króciec odpylania Makita 127672-7 (459234-6)

DC179

Title	Change of Arm set, Joint, Hose connector, Dust nozzle Elimination of O ring 20, O ring 23 Addition of Rivet 7
Model	DSL800, XLS01
Country	All countries
Description	To improve the dust collecting efficiency; • Arm set, Joint, Hose connector and Dust nozzle will be changed. • O ring 20 and O ring 23 will be eliminated. • Rivet 7 will be added.

[1] Arm set (183L76-5)

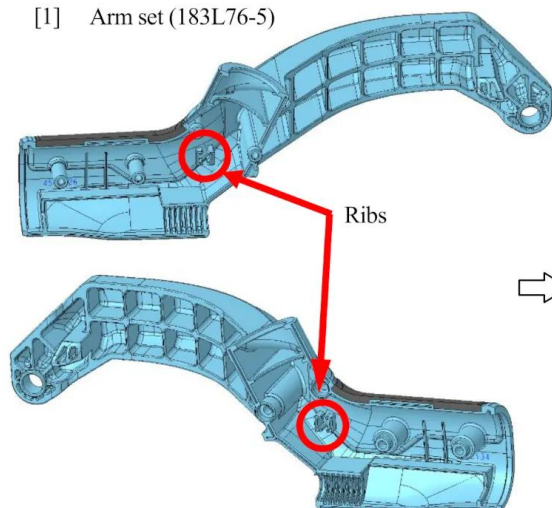
Arm set (183T15-3)

[2] Joint (459222-3)

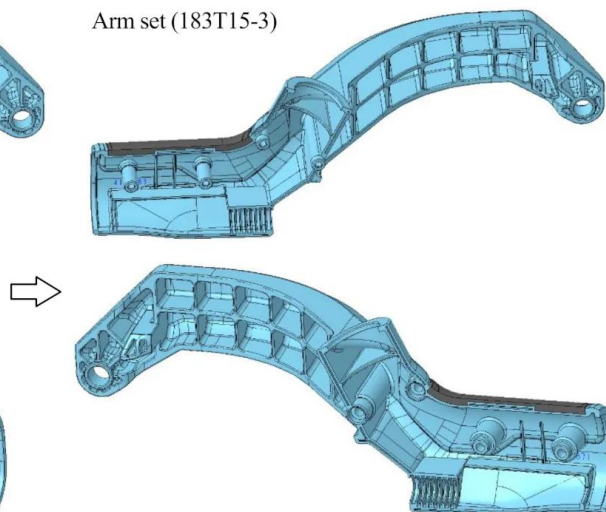
Joint (422617-3)

[3] Hose connector
(459223-1)

Hose connector
(413490-2)

- [4] Elimination of O ring 20 attached to the current Joint
- [5] Elimination of O ring 23 attached to the current Joint

[6] Dust nozzle (459234-6)

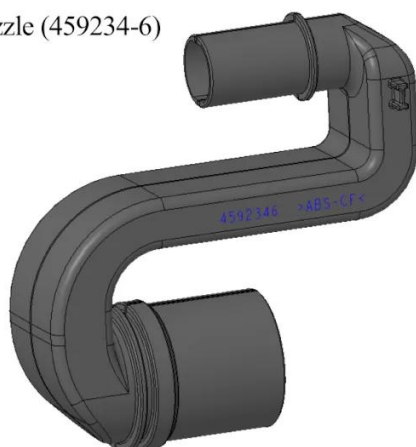
Dust nozzle assy (127672-7)

[7] Addition of Rivet 7 (412987-8)

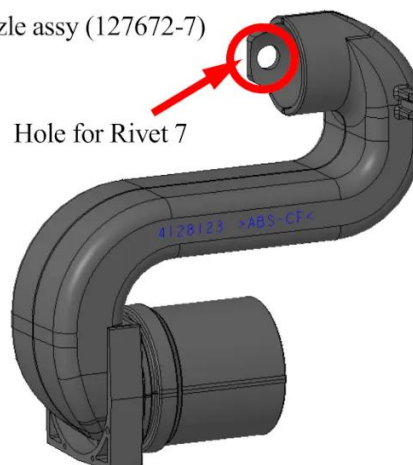
Pipe B complete

Insert Pipe B complete into Dust nozzle assy, then fasten them with Rivet 7 (412987-8).
